# 2120 Delaware Mixed-Use Project Final Environmental Impact Report

SCH#: 2007012097

Prepared for  
The City of Santa Cruz  
June 2008

# 1 RESPONSE TO COMMENTS

#### [Exhibit 8](#)

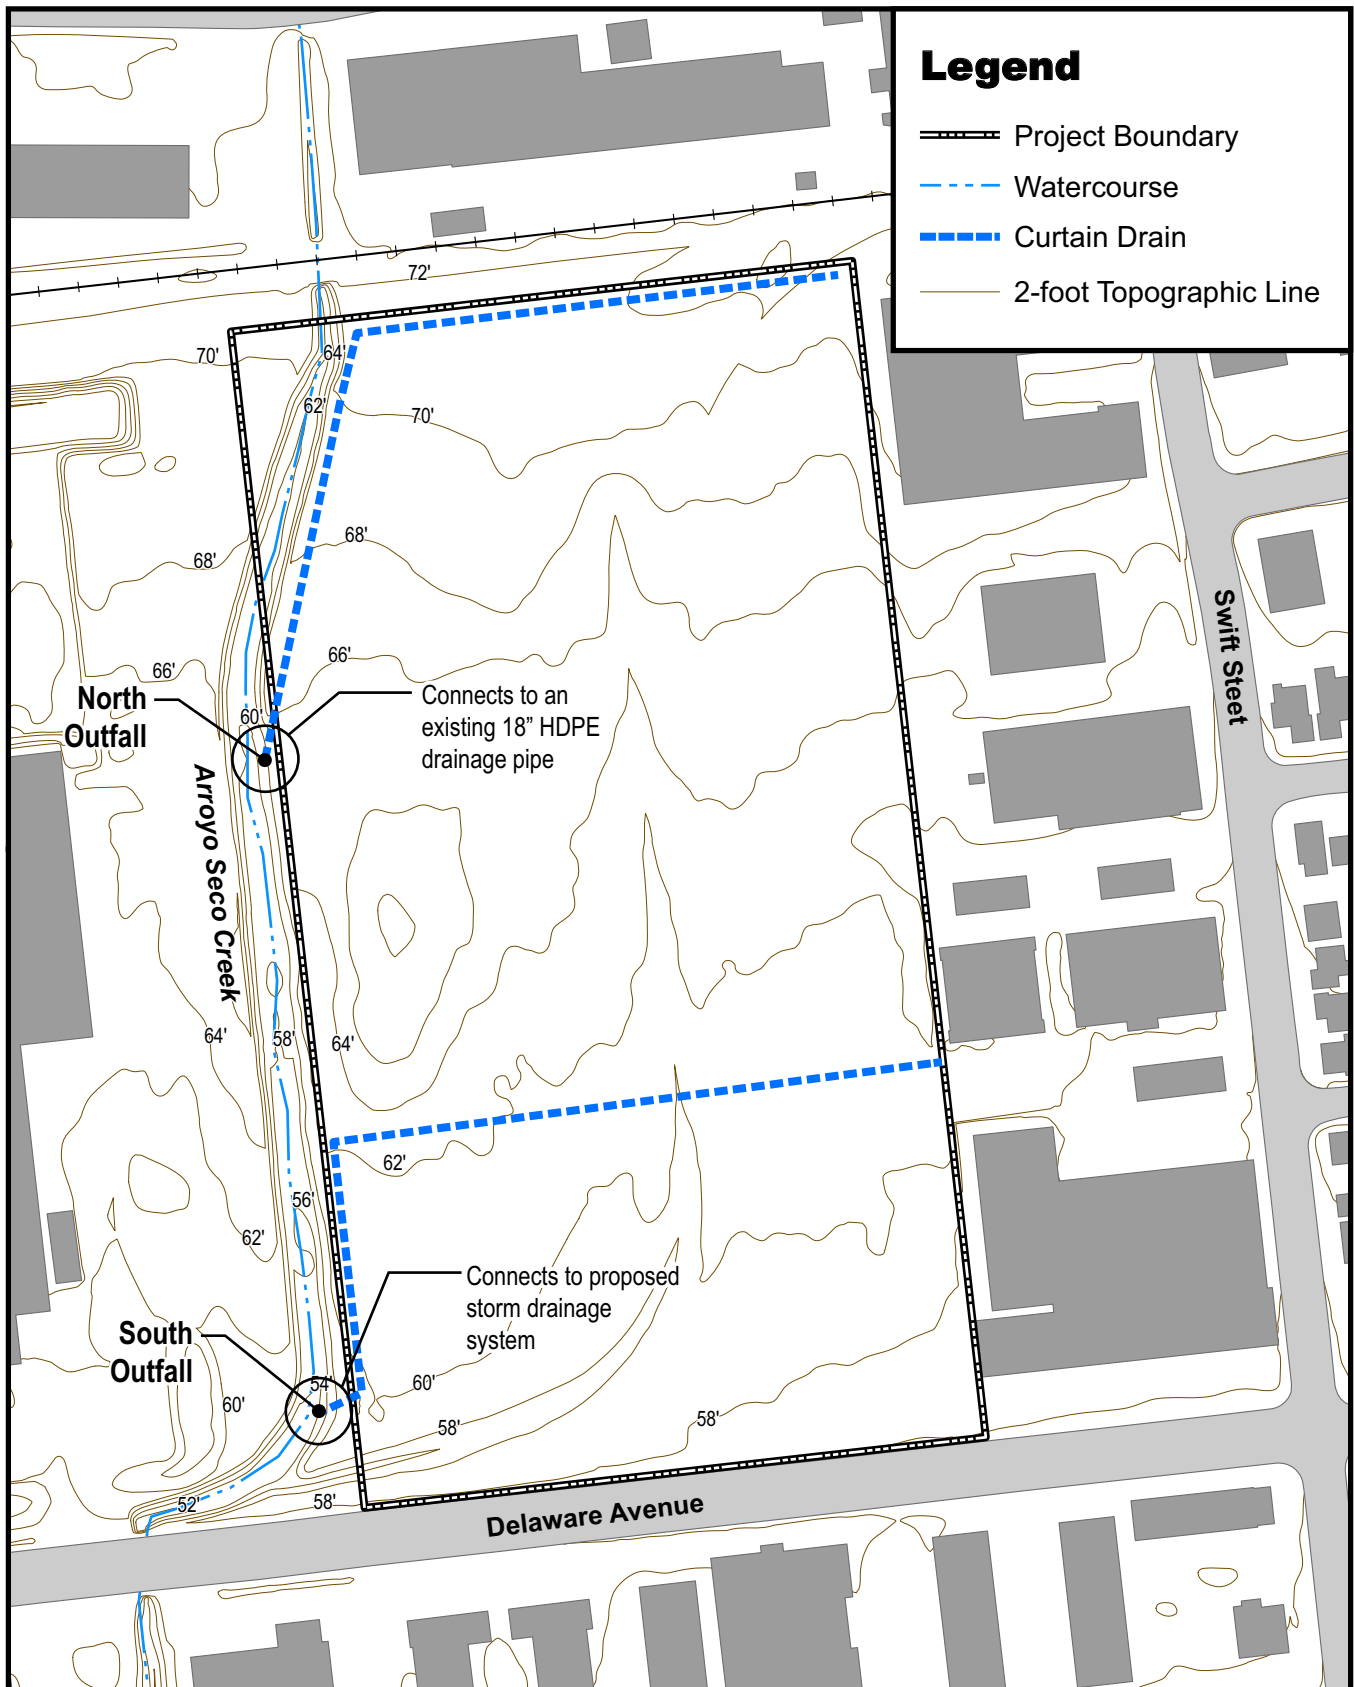
Include Trip Generation Buildout Table that was inadvertently omitted in the DEIR.

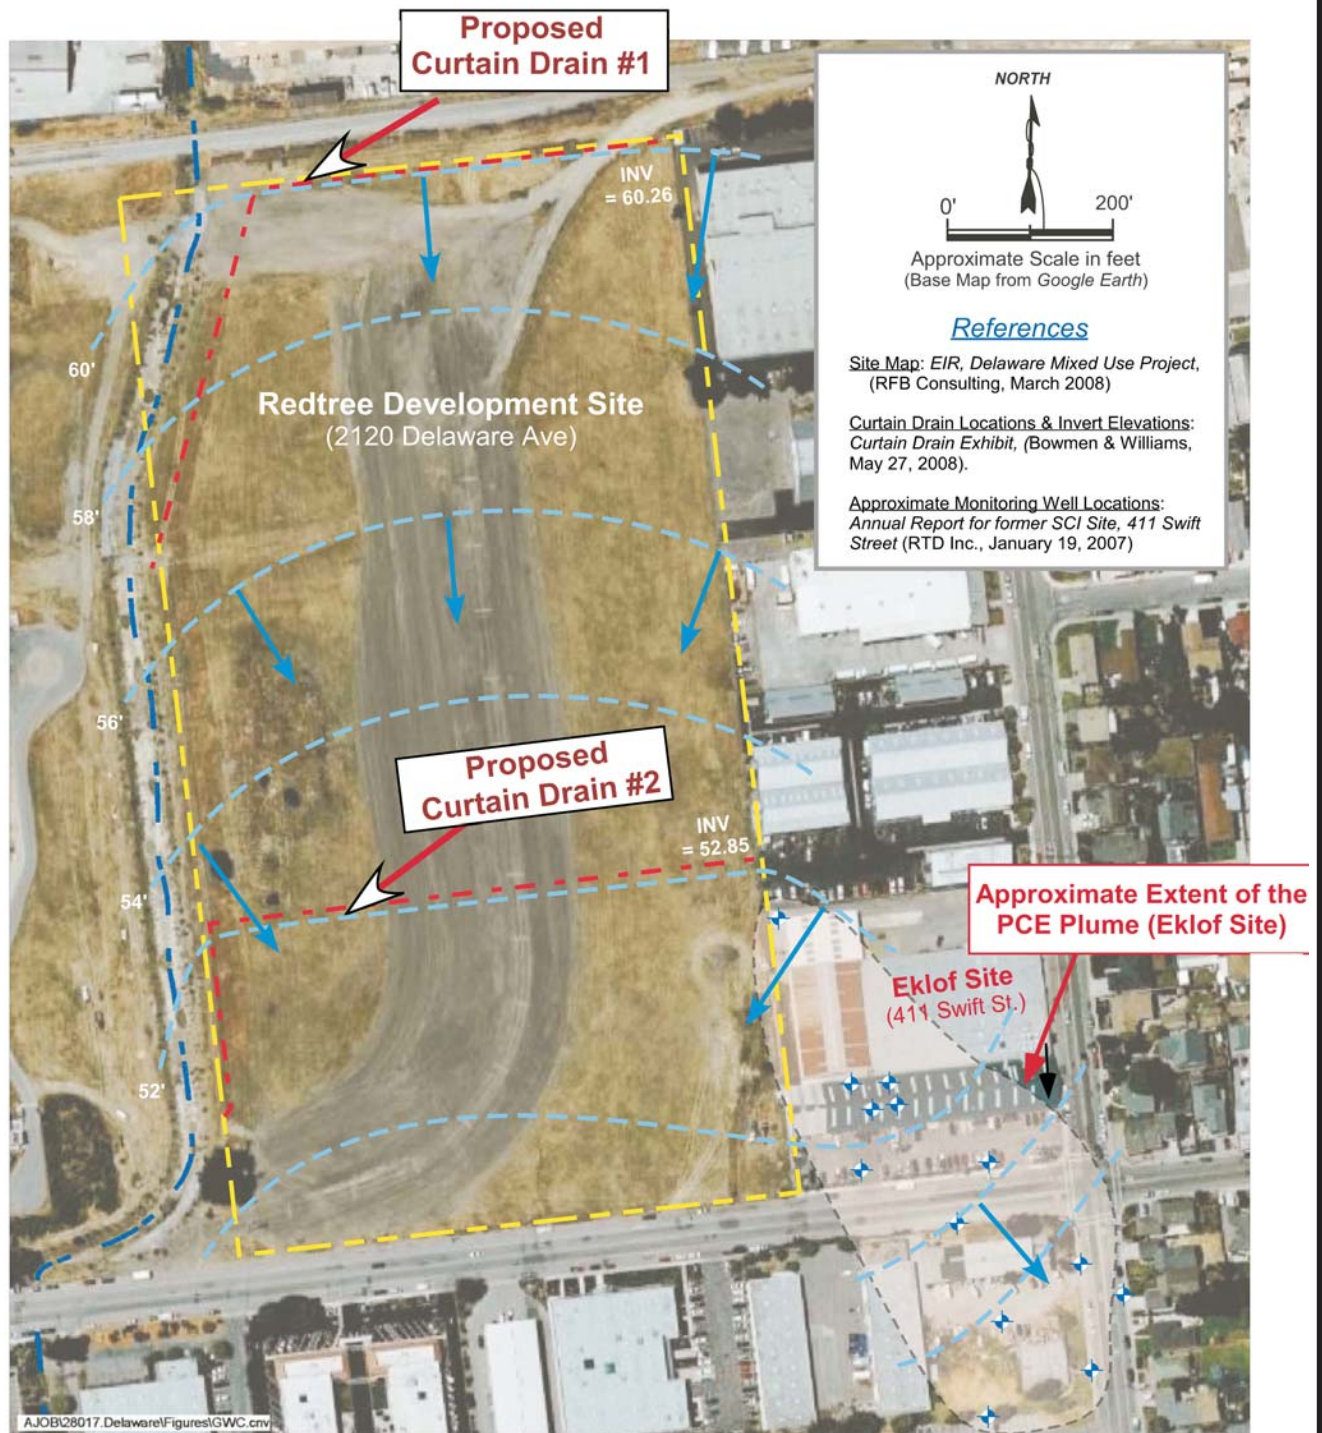
entire project site by several feet for soil excavation and recompaction (see (see revised Figure 4.2-1 at the end of this chapter for proposed drain locations and elevations).

According to the project's civil engineer, the recommended design solution to lower groundwater levels would be to construct two a "curtain drains" 10 feet below the ground surface extending east to west across the project site along the northern boundary of the project site 10 feet below the ground surface (see [Figure 4.2-1: Proposed Curtain Drain Location](#)). In addition to the originally proposed curtain drain along the northern site boundary, a second curtain drain across the site, approximately one-third of the distance north from the southern boundary, has been proposed since circulation of the Draft EIR to further reduce high groundwater levels and dewater the soils as needed for site construction (see Figure 4.2-1: Curtain Drain Locations). The southern curtain drain would discharge into the southern storm drainage system and would not require an additional outfall into the creek. A curtain drain consists of a perforated pipe placed in a trench filled with drain rock. Groundwater collects in the pipe and is conveyed into a

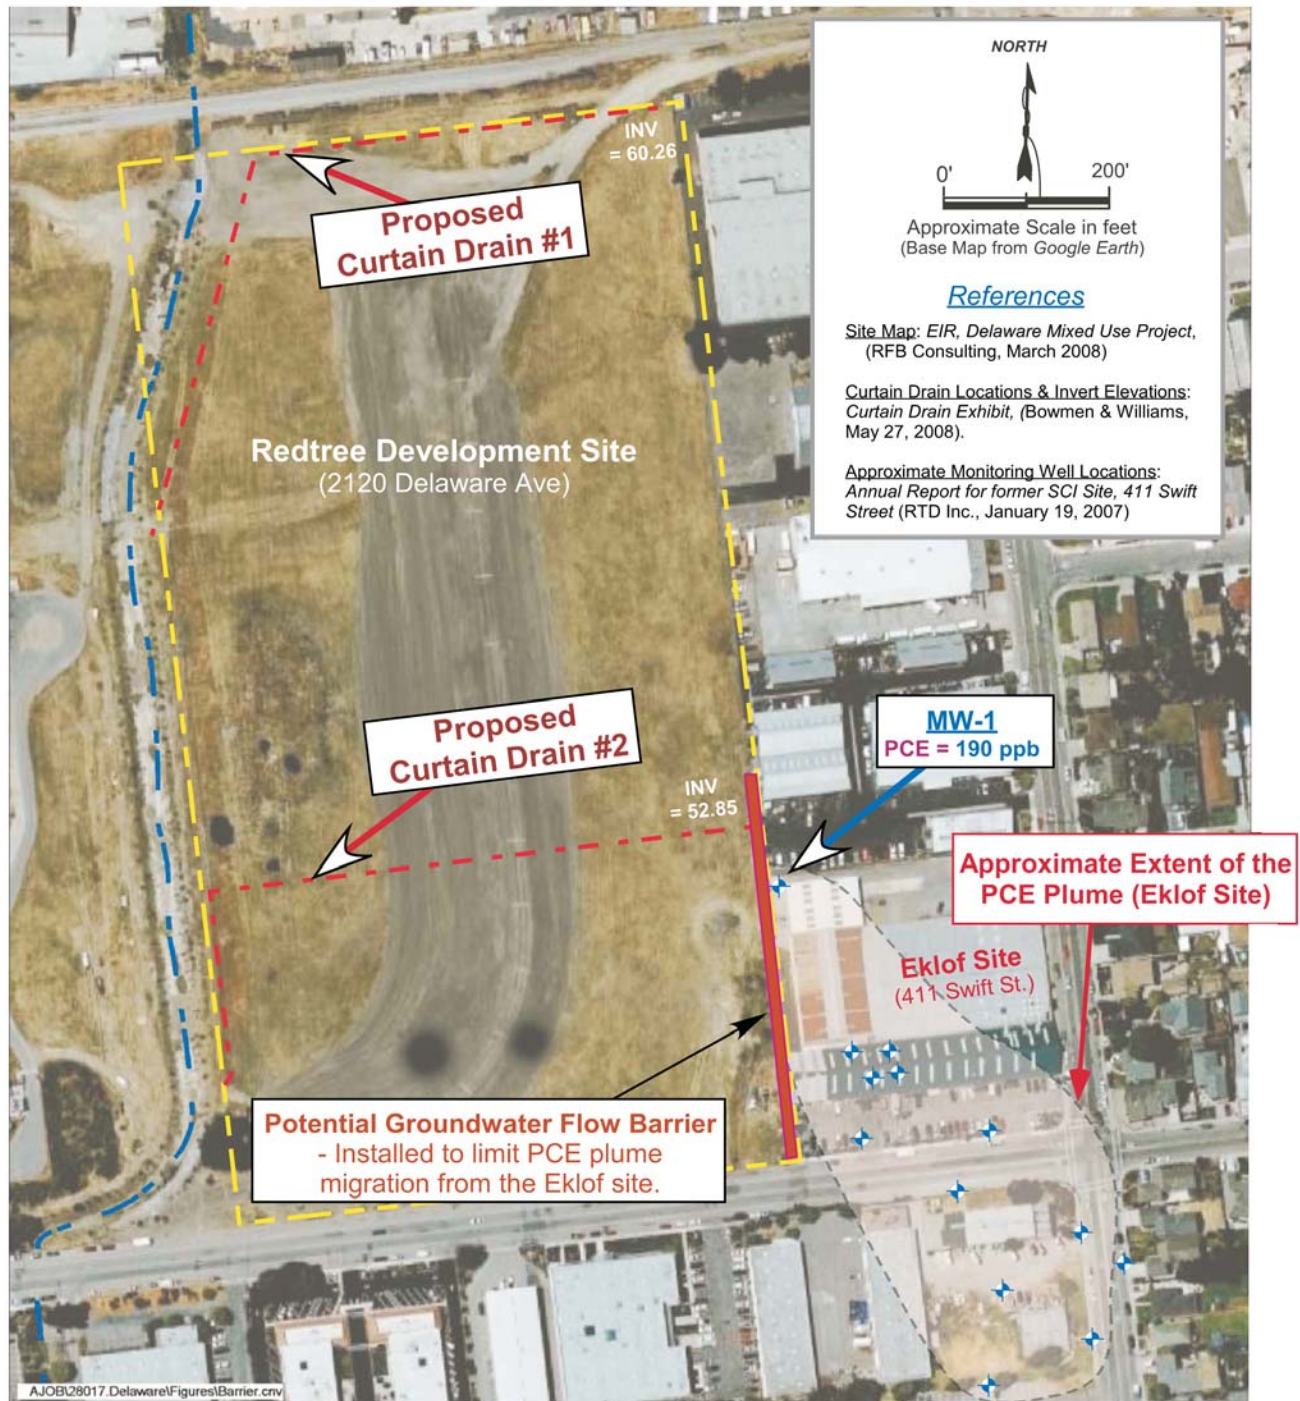
In order to show groundwater flow after dewatering has stabilized and hydraulic conditions are in equilibrium, a map of projected groundwater contours was developed. Figure 4.3-1: Estimated Groundwater Contours with Curtain Drains represents Weber, Hayes' analysis of the groundwater flow contours and direction that will develop under future conditions with dewatering drains installed and functional. Specific groundwater elevations will vary seasonally, but this overall flow condition is predicted based on the existing information, with the additional of known groundwater elevations at the proposed drain locations.

Once groundwater is stabilized and at equilibrium, the installation of curtain drains will induce some lateral groundwater flow from the east (from Swift Street side), causing relatively minor changes in shallow flow patterns. Local surface recharge to shallow groundwater and lateral groundwater flow may be induced from Arroyo Seco Creek drainage on the west (when it has surface water). Figure 4.3-1 p indicates that with dewatering there is a potential for some migration of groundwater from the adjacent Eklof solvent-release site property onto the Redtree project site, at the extreme southeast corner of the development. The overall impact once the drains have taken effect is expected to be a drop in local groundwater levels, with only slight shifts in the overall groundwater flow pattern.

Source: Santa Cruz City School District (2008)

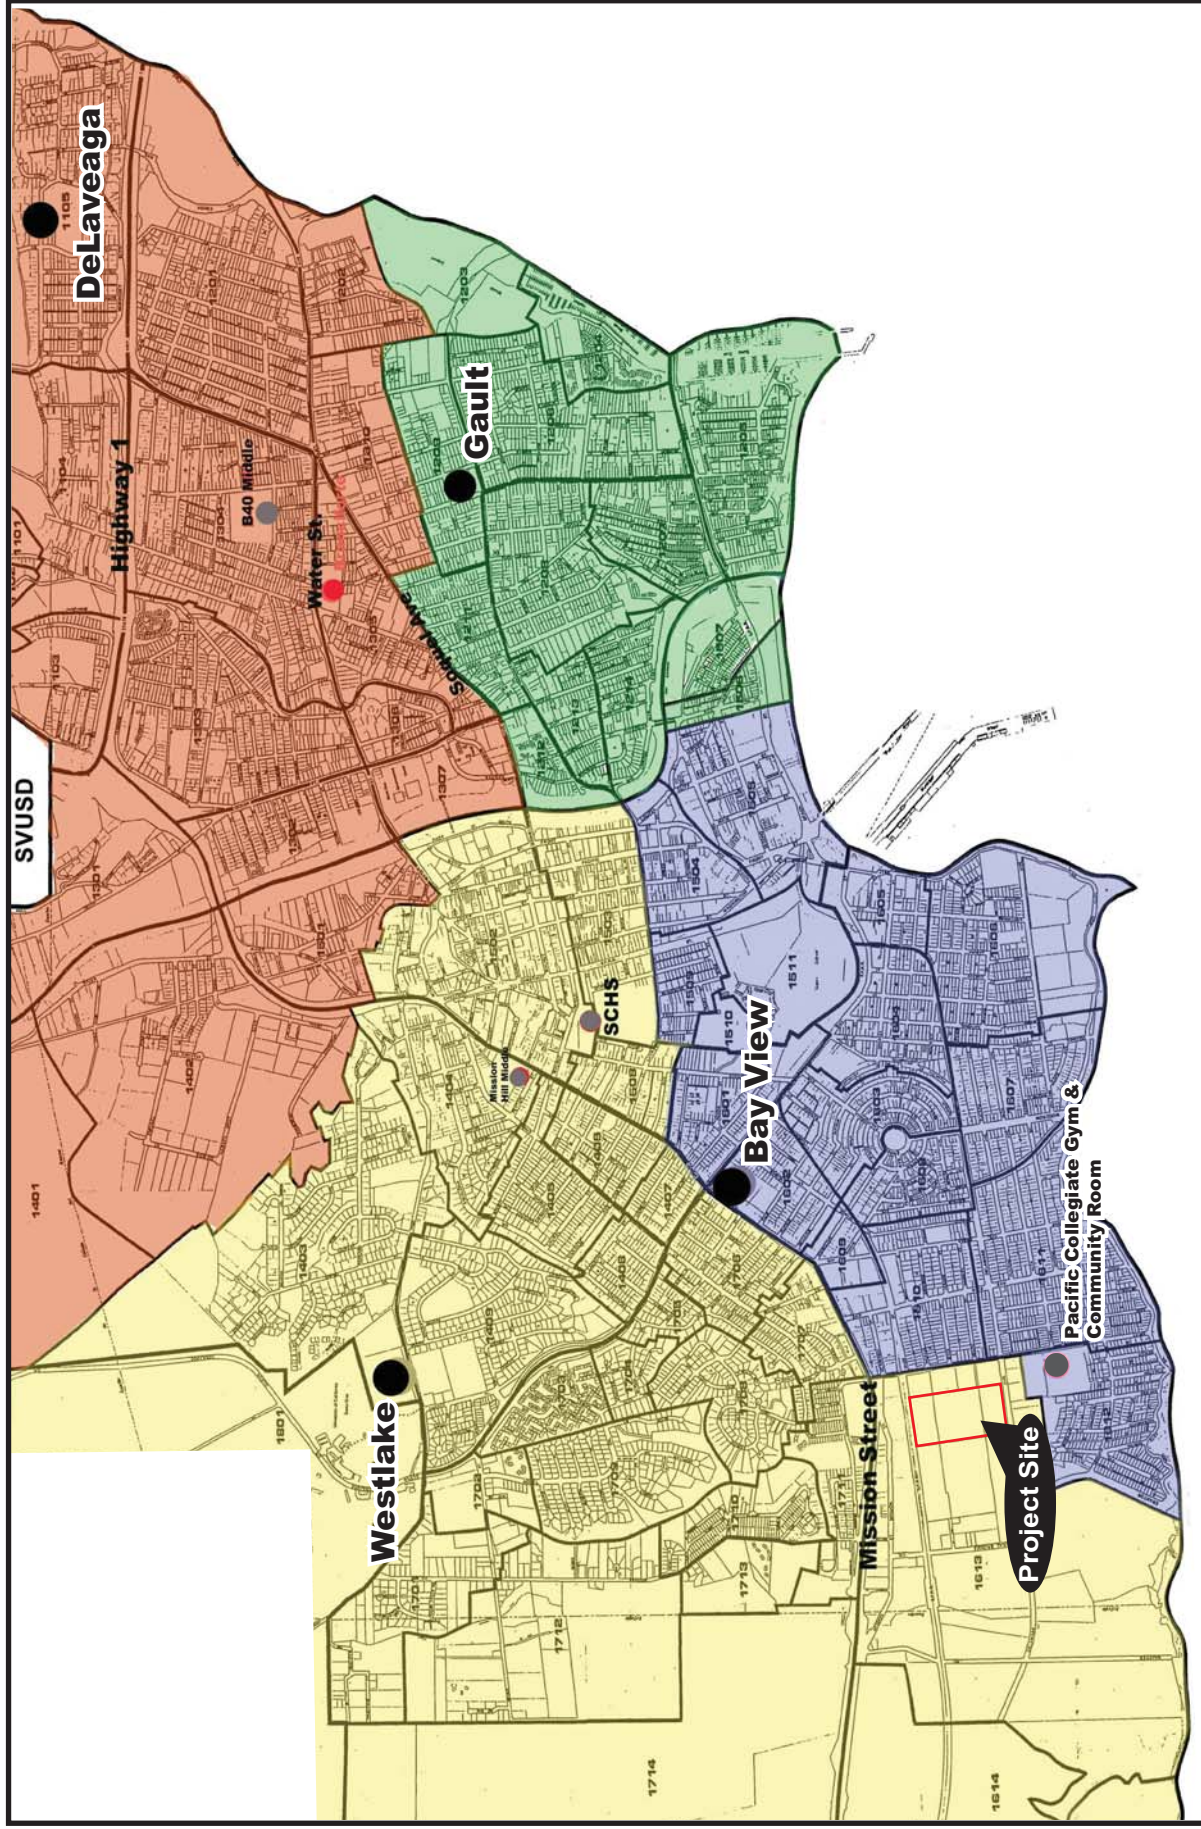
While the Bay View Elementary School is located closer to the project site than the Westlake Elementary School, the project site is not be served by this school (see [Figure 4.6- 2: Santa Cruz City School District Attendance Boundaries](#)).

The Draft EIR text and the table title has been changed to clarify that the schools listed in [Table 4.6-1: Santa Cruz City School District Nearby Schools](#), are those that will be serving the project site. Please see Chapter 2: Revisions to the Draft EIR, to see the revised Draft EIR text and [Figure 4.6- 2: Santa Cruz City School District Attendance Boundaries](#).
